2024 Annual Site Inspection

Defense Depot Memphis, Tennessee
U.S. EPA I.D. Number TN4210020570

Final
March 2025

Responses to:
U.S. Environmental Protection Agency (EPA) Region 4 Comments on:
Draft 2024 Annual Site Inspection Report Response to Comments
Defense Depot Memphis, Tennessee
Dated December 2, 2024
Comments Received January 17, 2025

Figure 1

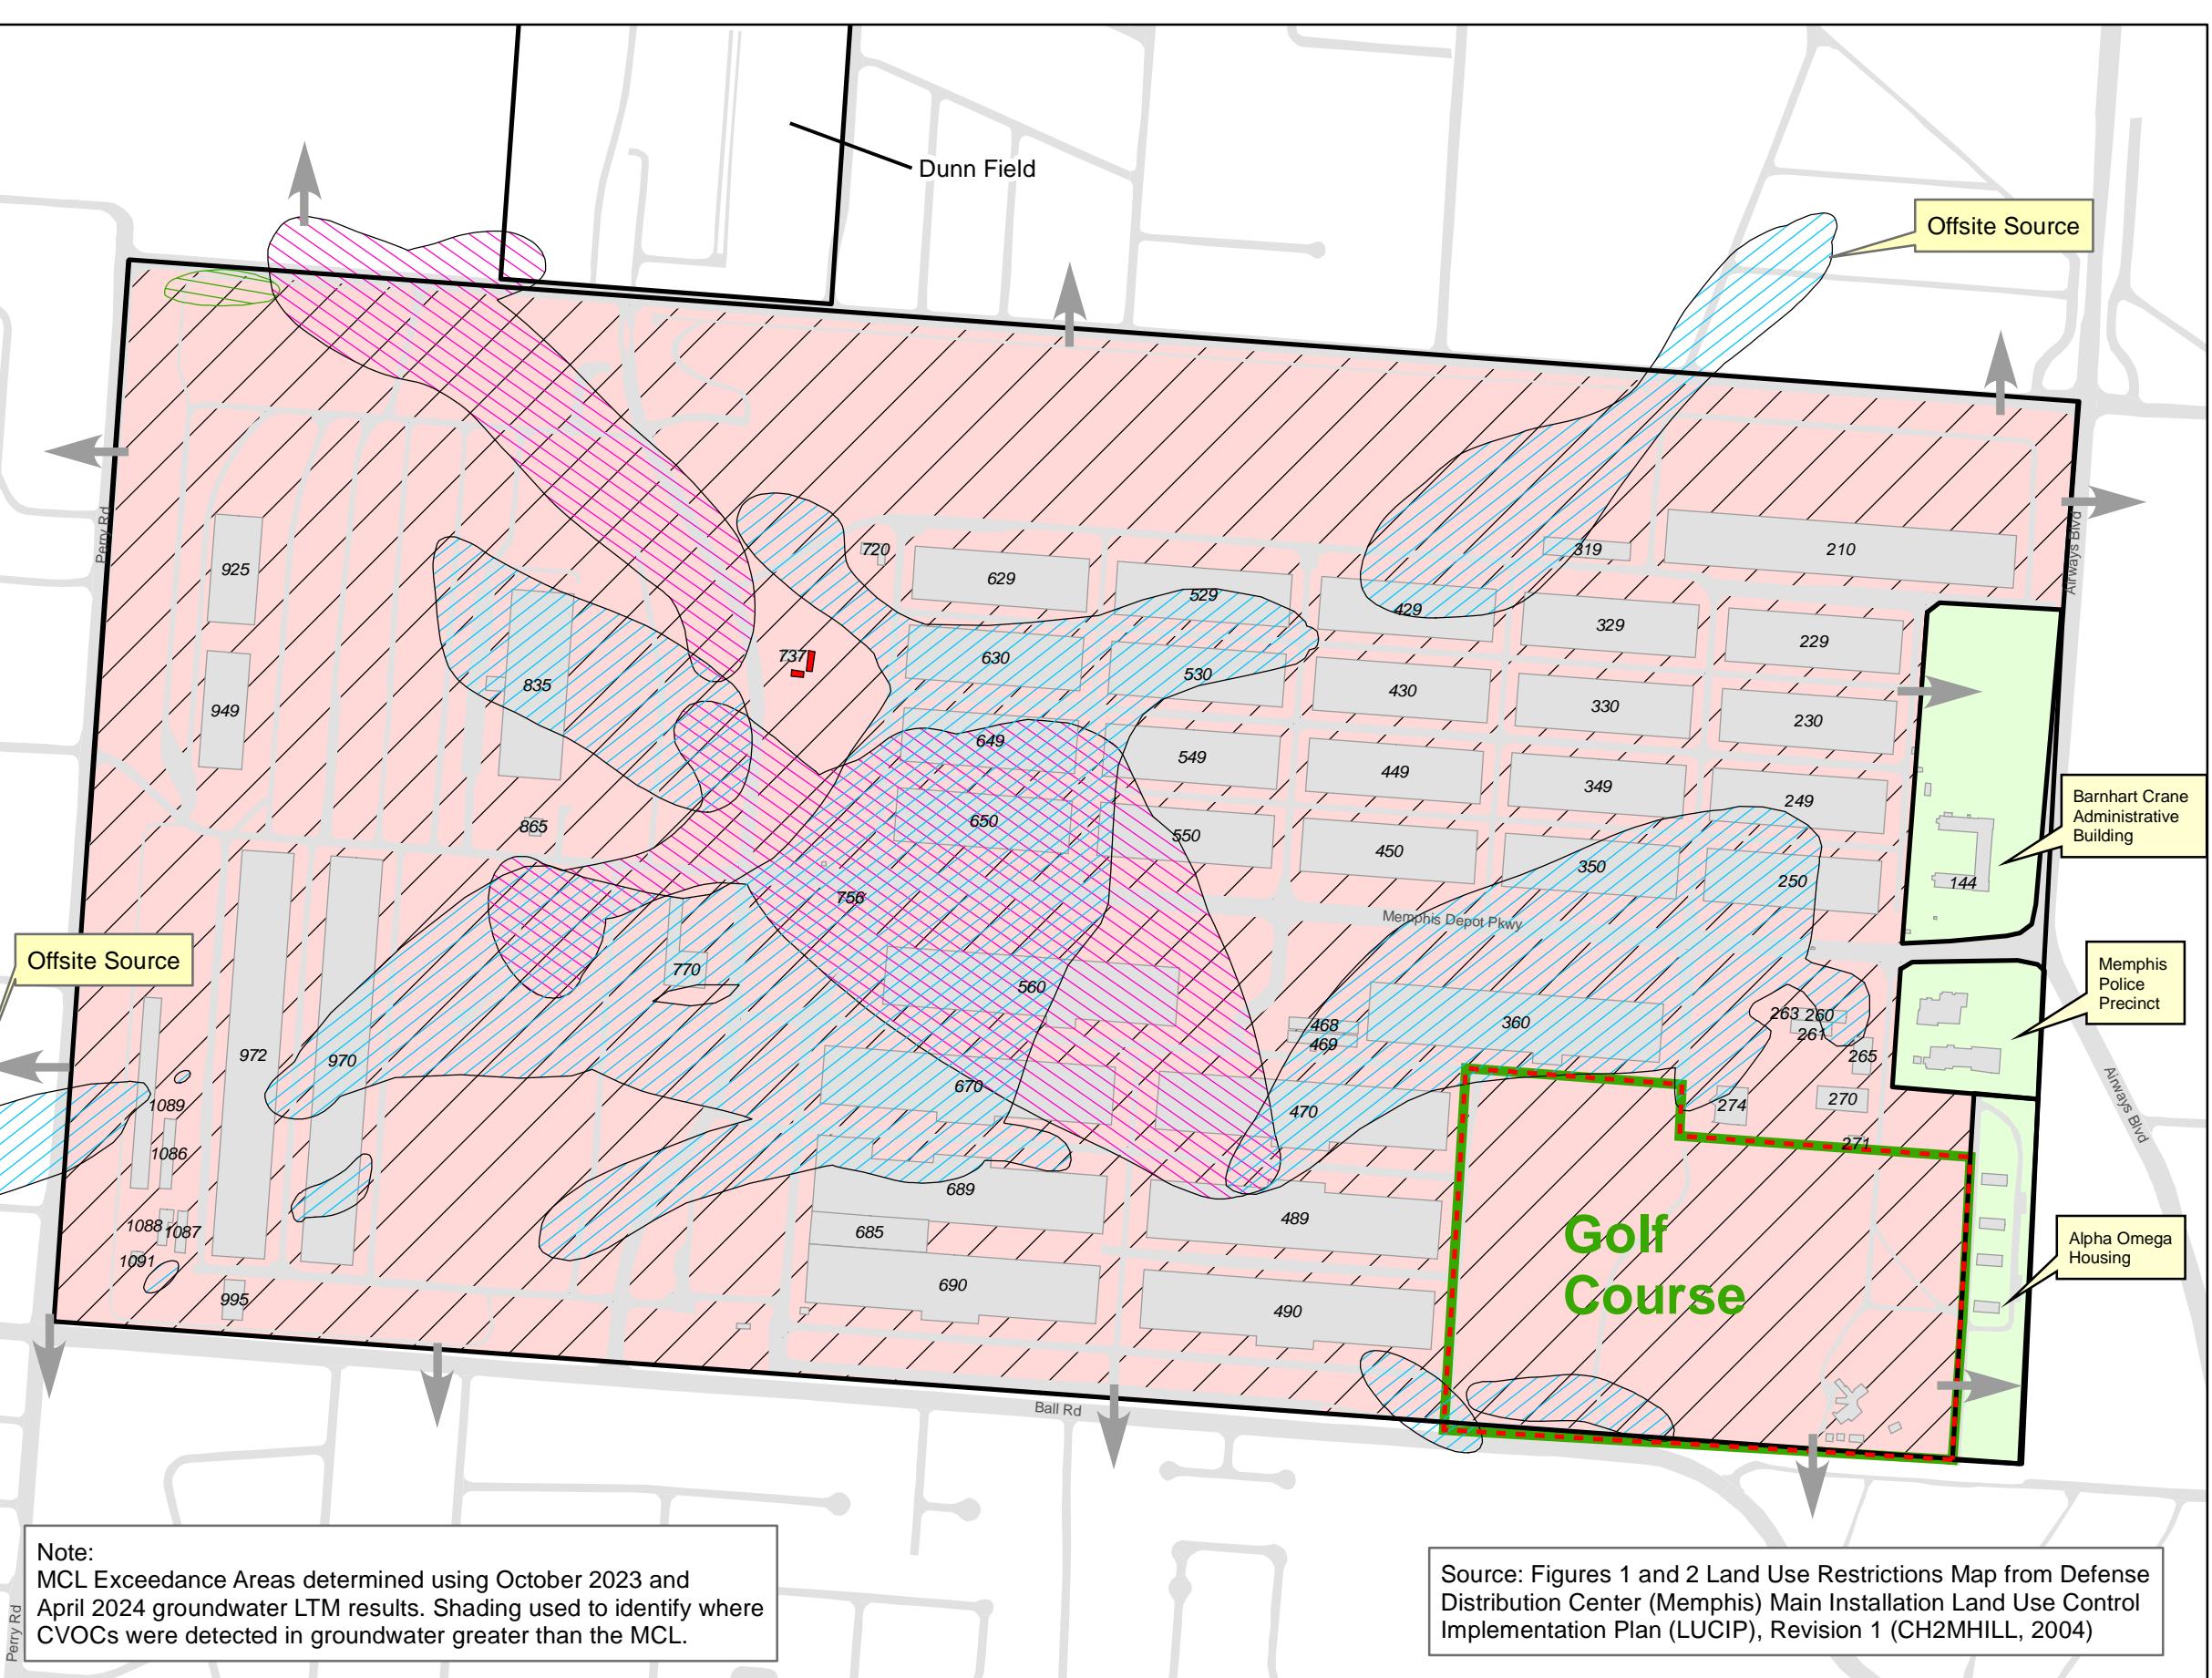
4. **Appendix E, Memphis Depot Industrial Park Tenant List and Ownership Map, PDF Pages 47 and 48:** It is unclear where the Alpha Omega housing area is located on the Appendix E figure of tenant locations. The Alpha Omega housing area is mentioned in the Contact Records of Cindy Forsythe, David Dingeldein, Leonard Perkins, and Sean Pedigo and in a photograph included in Appendix B (Site Photographs, May 29 and June 5, 2024); however, the location is not shown on the figure of tenant locations. Furthermore, it is unclear if the owner of this housing development is included in the current tenant list. Please revise the Appendix E tenant list and the Appendix E figure of tenant locations to identify the Alpha Omega housing area.

1. Comment for Response S4: Please confirm that Figure 1 will be updated to identify the Alpha Omega Housing area, Memphis Police precinct, and Barnhart Crane administrative building within the Unrestricted Use area, as suggested in your response.

Comment S1: Please confirm that Figure 1 will be updated to identify the Alpha Omega Housing area, Memphis Police precinct, and Barnhart Crane administrative building within the Unrestricted Use area, as suggested in your response.

Response S4: The Alpha Omega housing area is located on the parcel east of the Golf Course (Figure 1), within the area available for Unrestricted Use. This property was transferred to Alpha Omega Veterans Services in 2001, is not within the Memphis Depot Industrial Park and therefore not listed on the current tenant list. Figure 1 can be updated to identify the Alpha Omega Housing area, Memphis Police precinct and Barnhart Crane administrative building with the Unrestricted Use area.

Updated Figure 1 is attached.

Figure 2

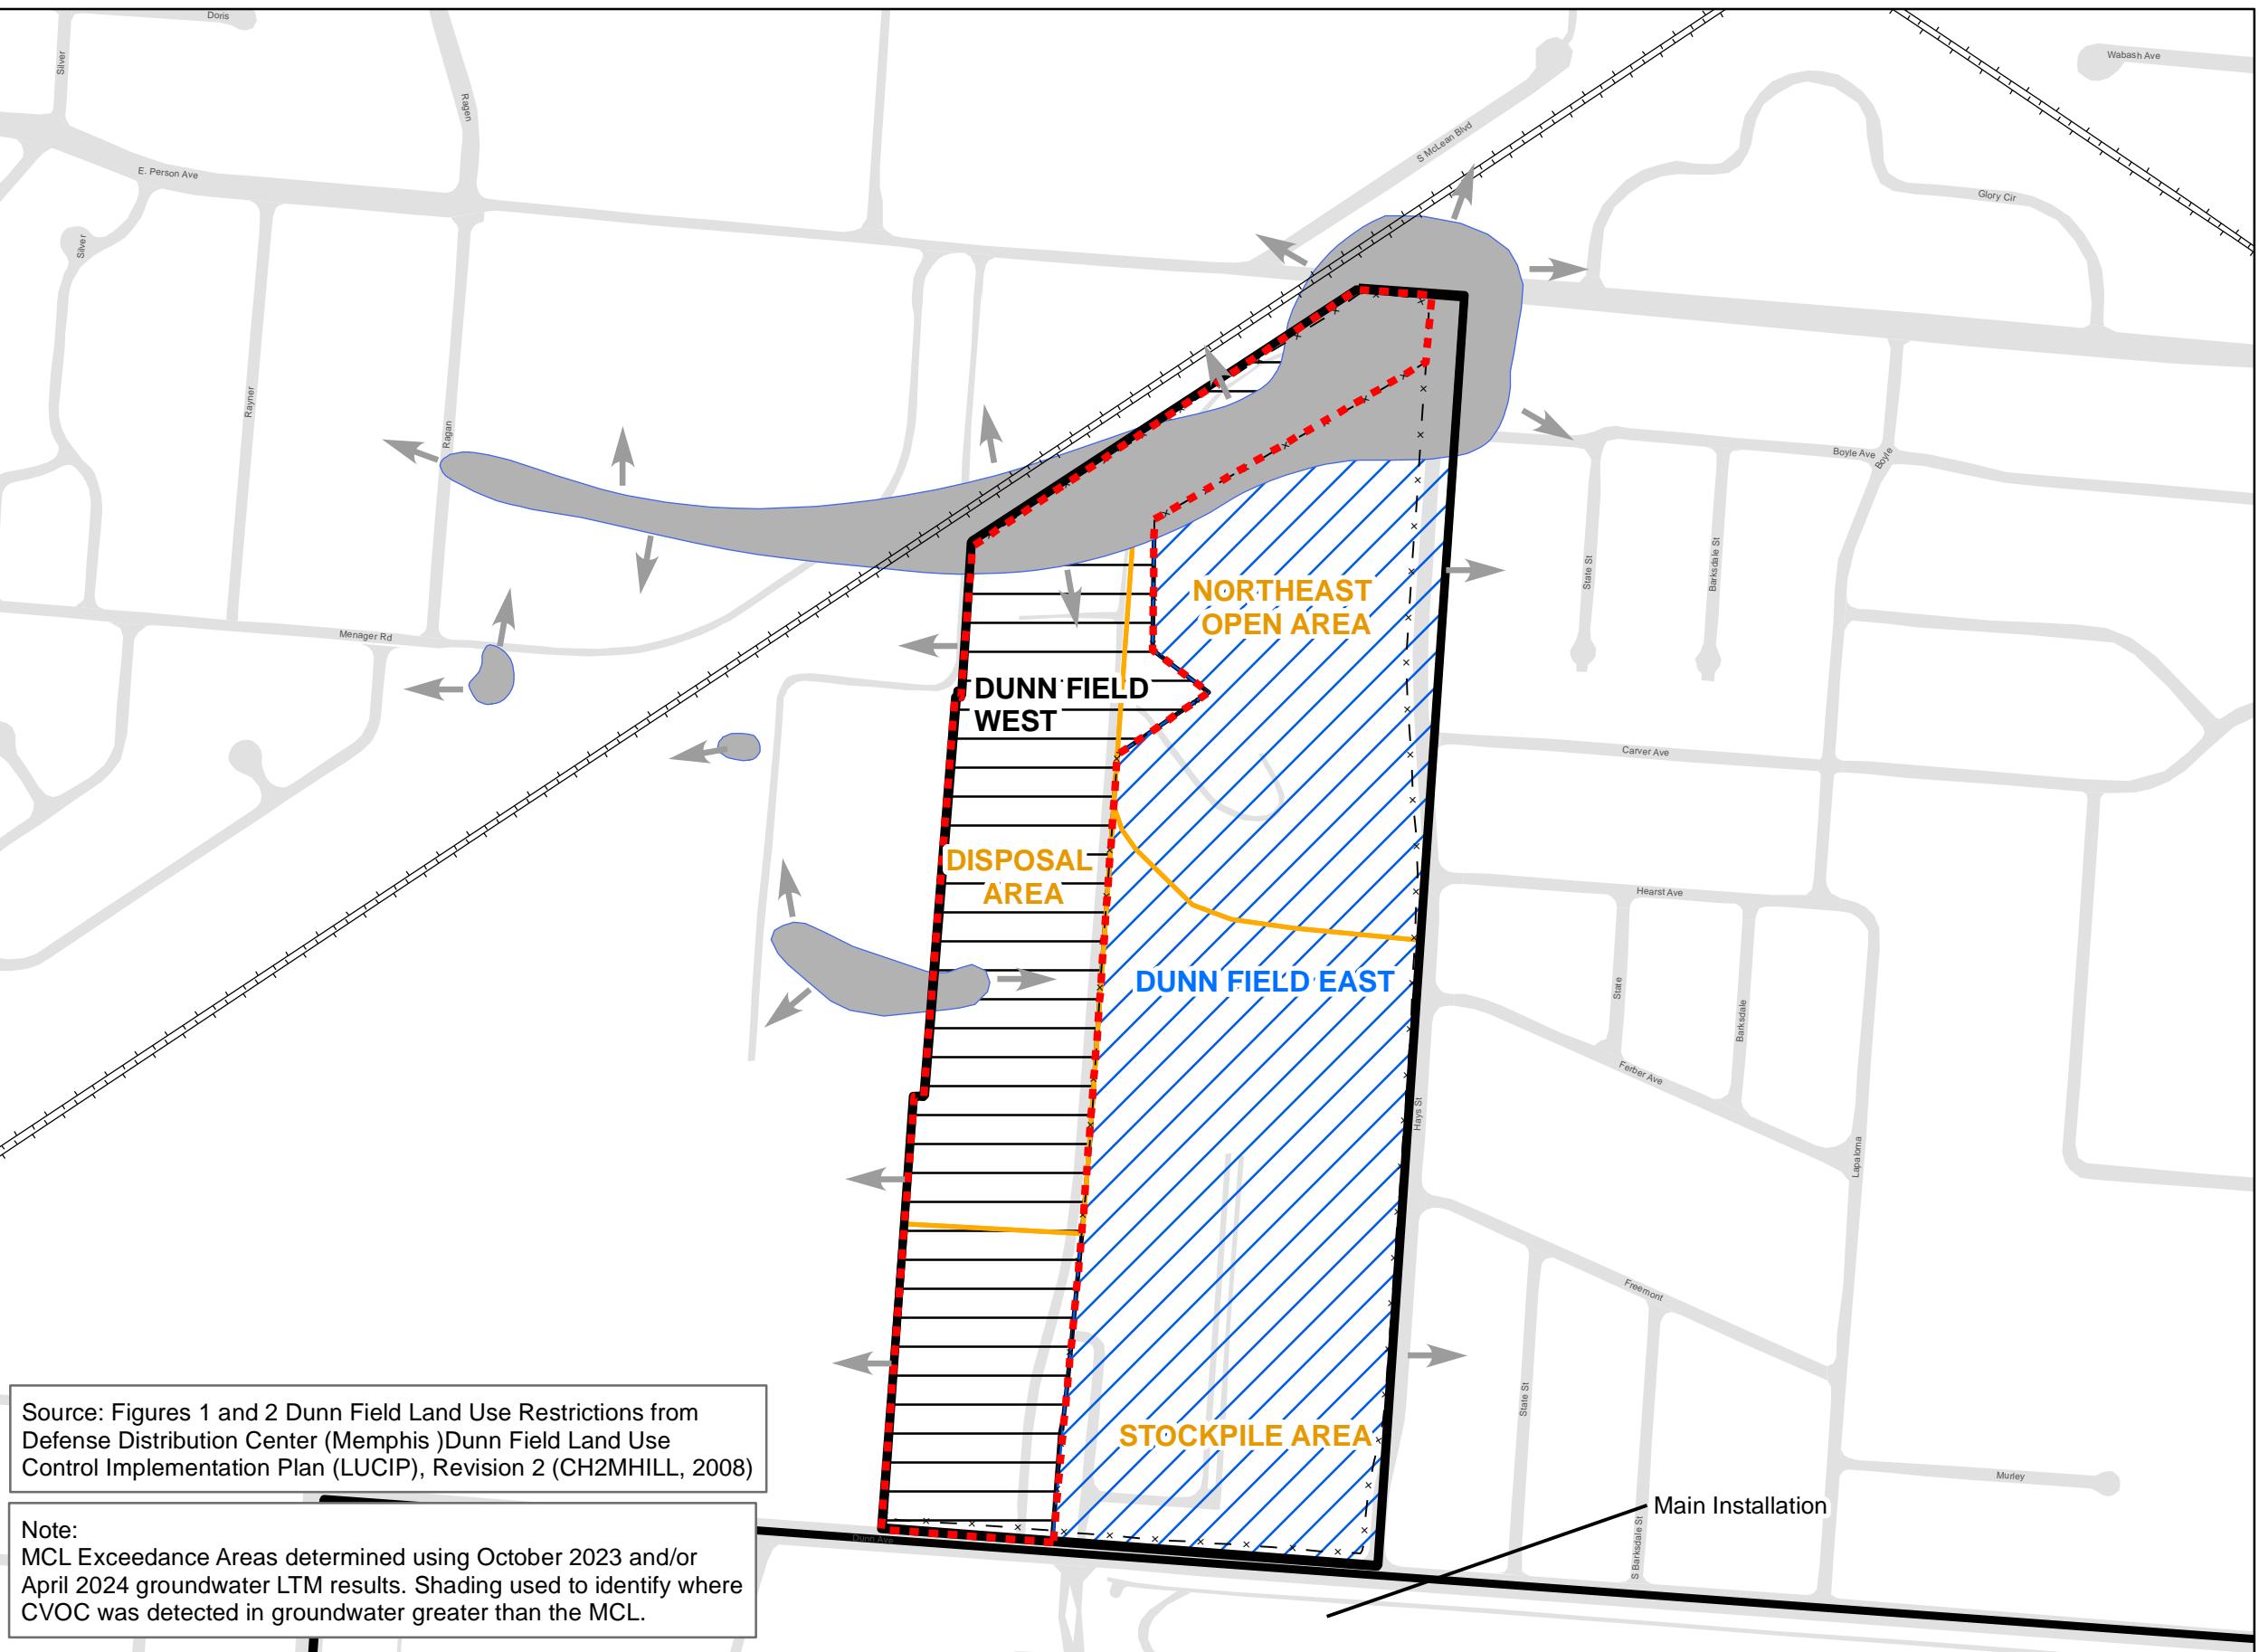
1. The report lacks clarity regarding the implementation of land use controls (LUCs) in off-site areas of Dunn Field West where groundwater contamination exceeds maximum contaminant levels (MCLs). While Figure 2 (Dunn Field Land and Groundwater Use Restrictions) shows off-site plume areas exceeding MCLs, it is unclear whether LUCs are in place to restrict exposure and certain land uses in these areas, specifically to protect against the potential for vapor intrusion. The report mentions a visual inspection of Dunn Field and the off-site property conducted on May 29, 2024; however, it does not specify if this visual observation included the residential homes located west of Dunn Field West. This omission raises concerns about whether potential exposure risks in those residential areas have been adequately assessed.

1. The report lacks clarity regarding the implementation of land use controls (LUCs) in off-site areas of Dunn Field West where groundwater contamination exceeds maximum contaminant levels (MCLs). While Figure 2 (Dunn Field Land and Groundwater Use Restrictions) shows off-site plume areas exceeding MCLs, it is unclear whether LUCs are in place to restrict exposure and certain land uses in these areas, specifically to protect against the potential for vapor intrusion. The report mentions a visual inspection of Dunn Field and the off-site property conducted on May 29, 2024; however, it does not specify if this visual observation included the residential homes located west of Dunn Field West. This omission raises concerns about whether potential exposure risks in those residential areas have been adequately assessed.

- **Comment:** While Figure 2 (Dunn Field Land and Groundwater Use Restrictions) shows off-site plume areas exceeding MCLs, it is unclear whether LUCs are in place to restrict exposure and certain land uses in these areas, specifically to protect against the potential for vapor intrusion.
- **Response:** Figure 2 in the subject report identifies areas of Dunn Field where LUCs have been established. DF LUCs only apply to property owned by Army; however, Section 4.01 C of the Rules and Regulations of Wells in Shelby County prohibits the installation of wells within a half-mile of a Superfund Site and associated plumes. A well search by TDEC and the SCHD did not identify water wells within a half-mile of DDMT or associated plumes (Appendix F). Installation of private water wells is not allowed in areas served by Memphis Light Gas and Water, which includes the area surrounding DDMT.

- **Comment:** The report mentions a visual inspection of Dunn Field and the off-site property conducted on May 29, 2024; however, it does not specify if this visual observation included the residential homes located west of Dunn Field West. This omission raises concerns about whether potential exposure risks in those residential areas have been adequately assessed.

- **Response:** Army does not have or intend to pursue access agreements for visual inspection of homes adjacent to Dunn Field. During Long Term Monitoring (LTM) events, observations are made from the public right of way and when accessing LTM wells for water supply wells. Water supply wells have not been identified during LTM events and a statement documenting the visual inspection can be added to the Draft Final 2024 Annual Site Inspection Report. As stated above, a vapor intrusion investigation is being conducted for the Rozelle St. area west of Dunn Field and the results of this investigation will be shared with EPA in early 2025.

- **Response:** Table 2 of the report identifies the Type of Control (e.g. LUC, zoning restriction), the Affected Area, and Monitoring Frequency. Community outreach is conducted by Army in accordance with EPA *Superfund Community Involvement Toolkit* ("CI toolkit") and the approved *2020 Community Involvement Plan*, which include: maintenance of a CIL, prompt response to community questions, EnviroNews distribution to over 4,500 recipients, public notification of five-year reviews, and document uploads to the publicly available information repository. EPA is informed of all community outreach activities and investigation activities during monthly calls; inclusion of this information in the subject report is not warranted.
